# Ordinary Meeting

CL01 DA 203/2023 - Attached Two-storey dual occupancy development with Strata Title Subdivision

## Attachment A – Draft Conditions of Consent

SOUTH ELEVATION  
1 : 100

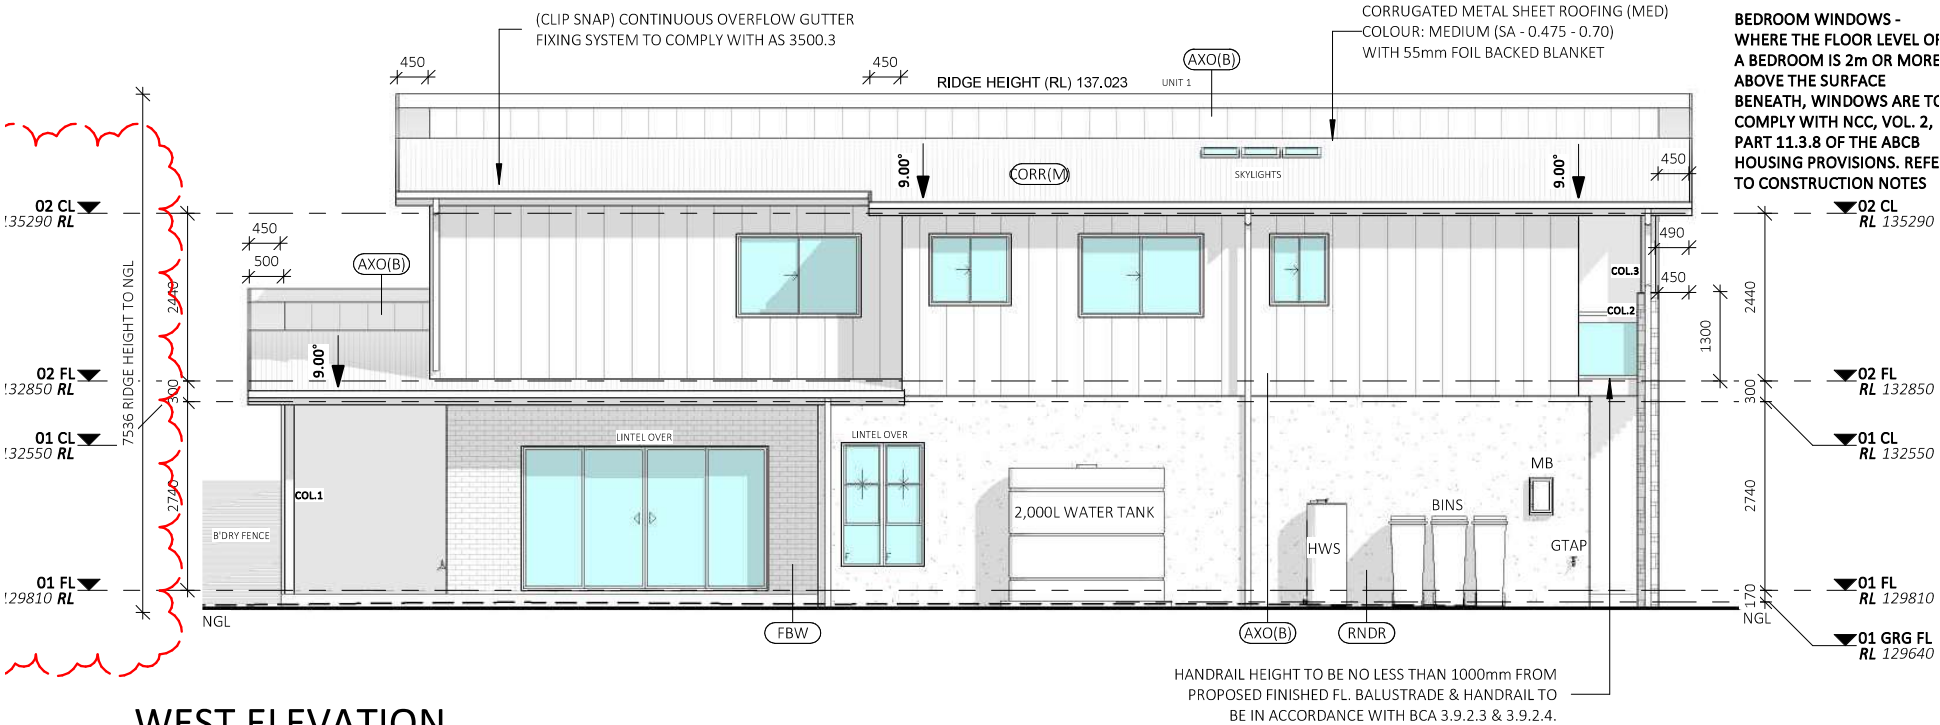
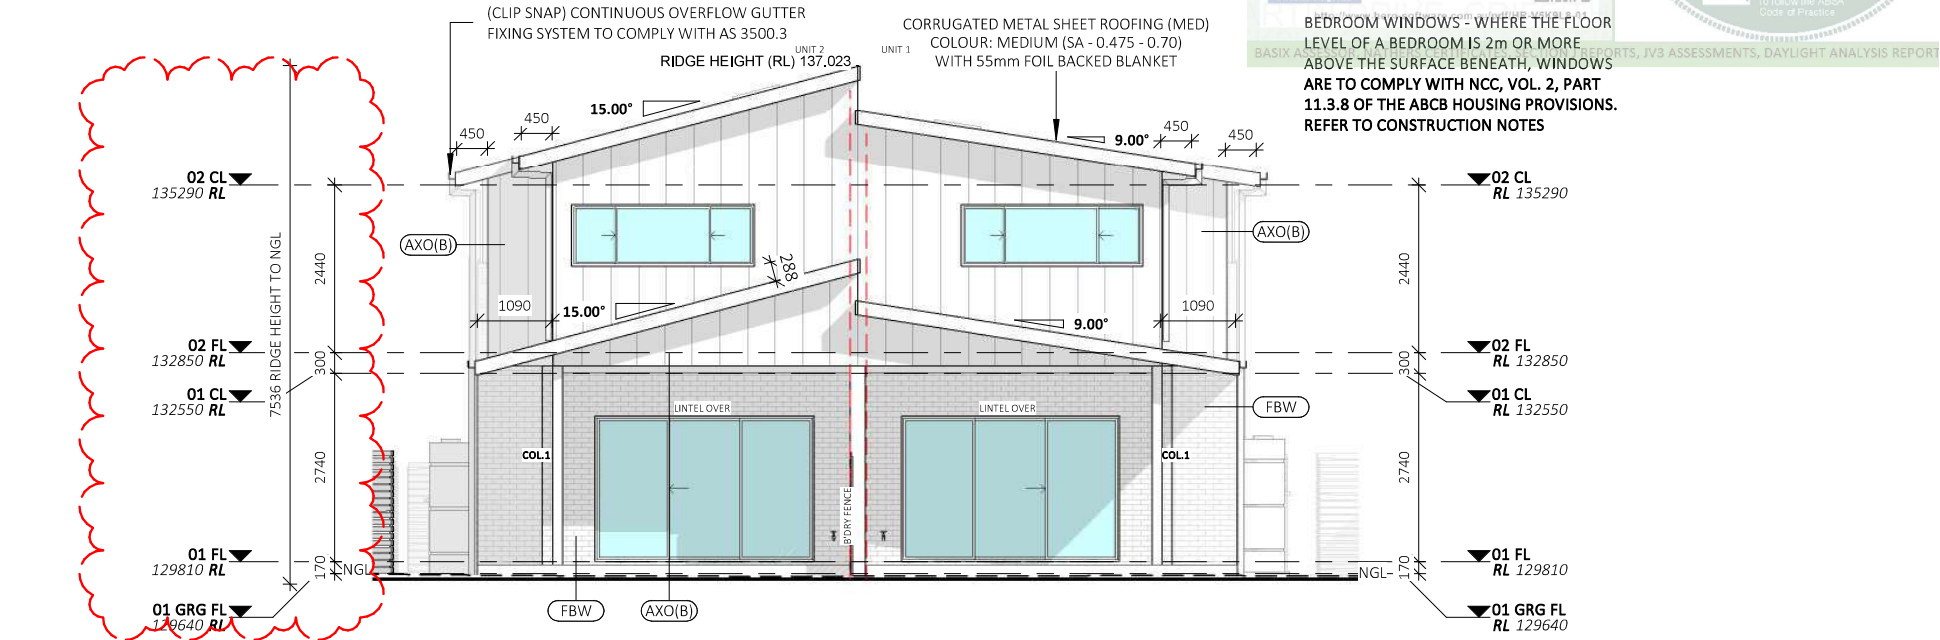
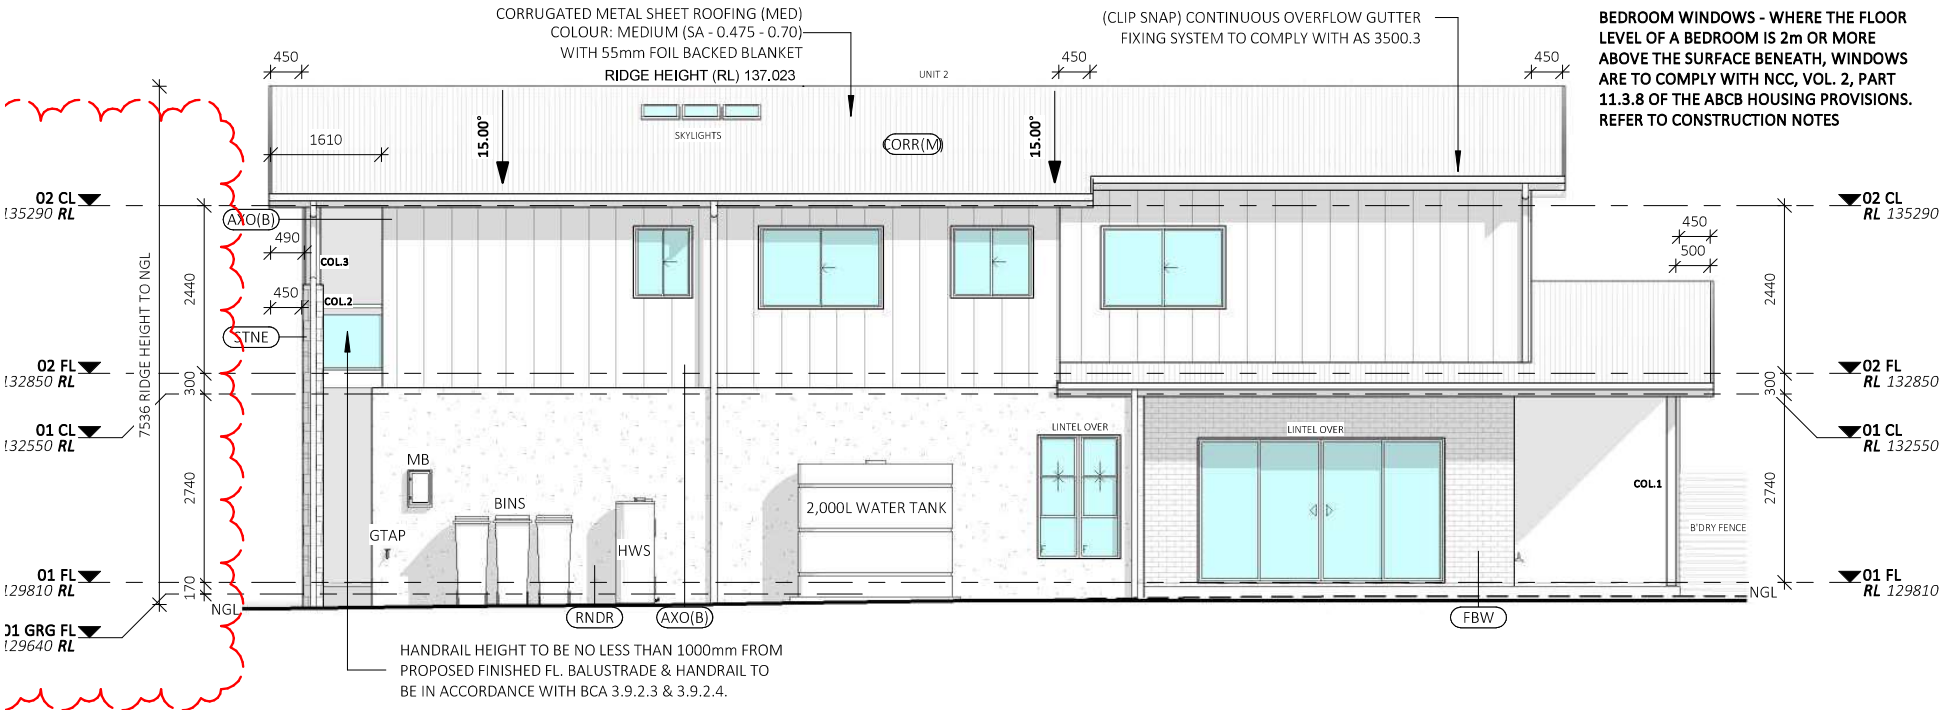
- I question the compliance of the ground floor height against the natural ground. It appears that the applicant wishes to have a finished floor height of 300mm above natural ground. The common practice within the Griffith Council is to have the slab 410mm above ground (Griffith

City Council Building Floor Heights CS-CP-318, March 2013). Can the applicant provide details as to why they believe this proposed building does not need to comply with this 1 in 100 year ARI flood requirement? Upon reviewing page 2 of the Collins W Collins architectural drawings, it clearly displays the height at the front of the block at RL129.400, with a slab height of RL129.700 for the unit, with the garage 100mm lower (RL129.600). Why has the 300mm above slab height been adopted, as opposed to 410mm. Is this a cost cutting measure by the applicant? If this development was to be passed by council, the garage would be at the same height as the natural ground at the rear of the house, due to the topography of the lot. These heights are clearly displayed with the elevation drawings supplied and council should consider this in determining the application.

<b>Sewer</b>	Will the proposed development use one sewer connection to the council sewer for both dwellings?	The proposal comprises a dual occupancy with Strata subdivision and will utilise one sewer connection.
<b>Floor level</b>	I question the compliance of the ground floor height against the natural ground. It appears that the applicant wishes to have a finished floor height of 300mm above natural ground. The common practice within the Griffith Council is to have the slab 410mm above ground (Griffith City	As per Rev D plans, the floor level has been increased to provide 410mm above ground level.

9AM SHADOW WINT. SOLS.  
1 : 350

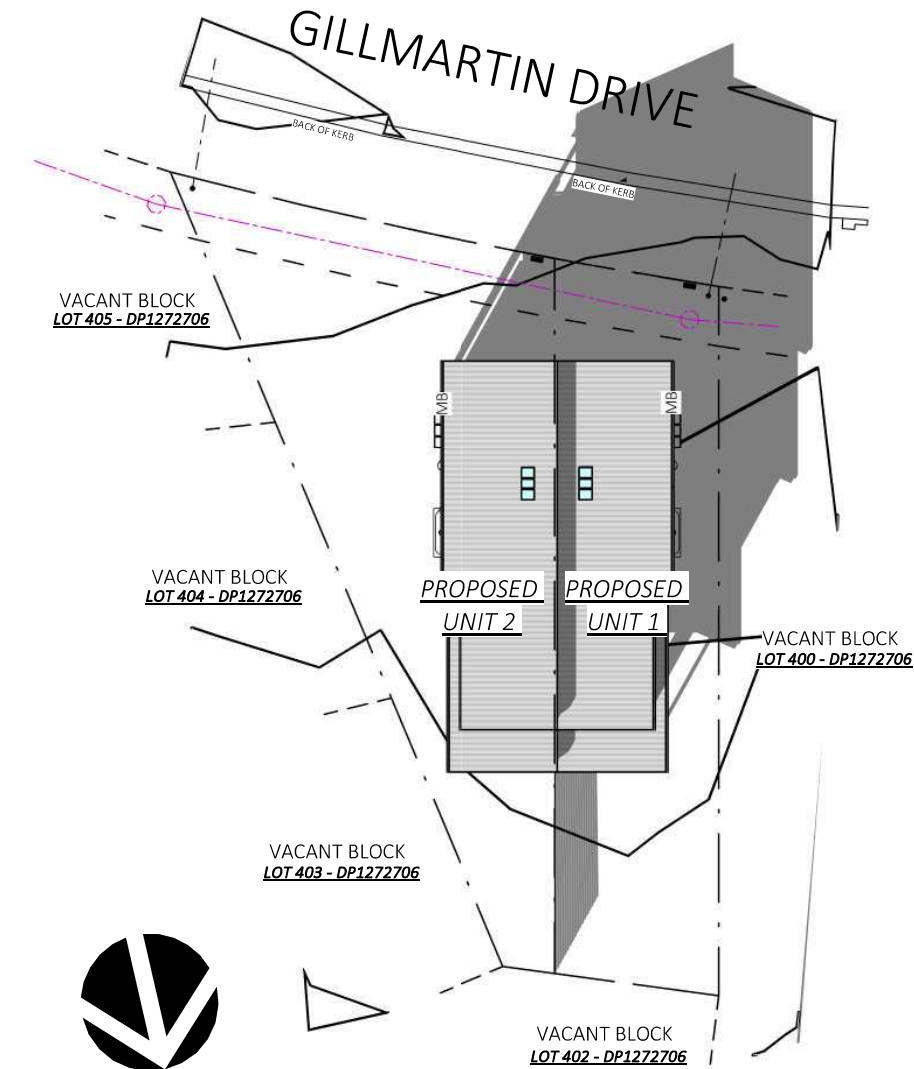
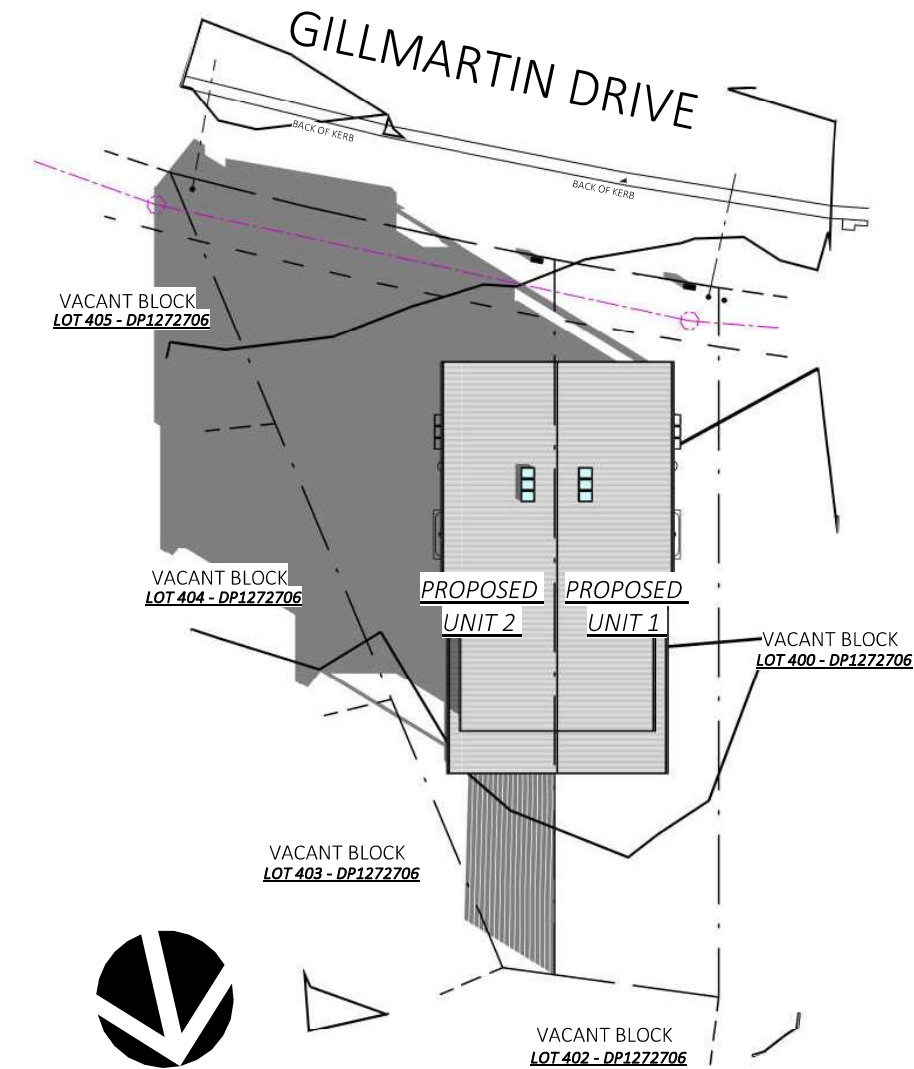
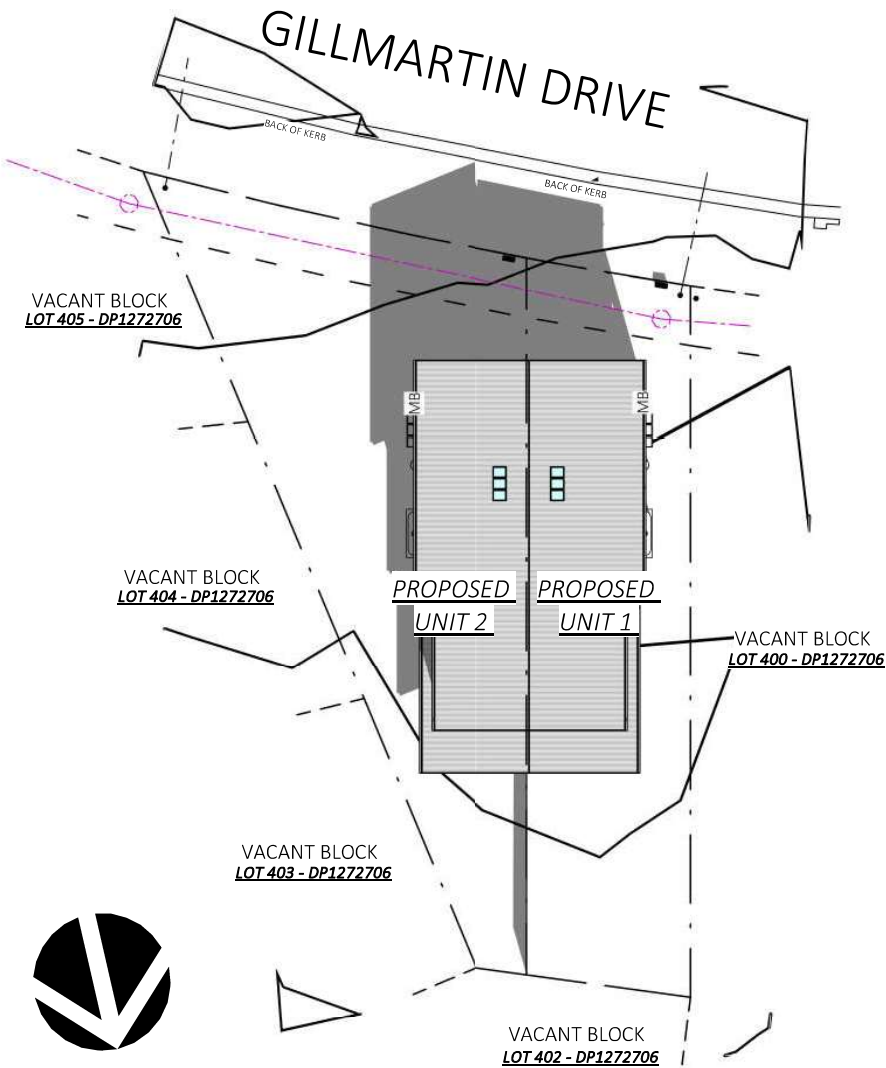
As our property already has a small backyard sun will be very limited which will also make it hard to grow plants and lawn.

Are we able to see the proposed plans and shadow diagrams?

For the unfortunate person who has to live next to this building, their yard is going to be shaded, ruining any plans for a garden. This is assuming that anyone will still buy that block.
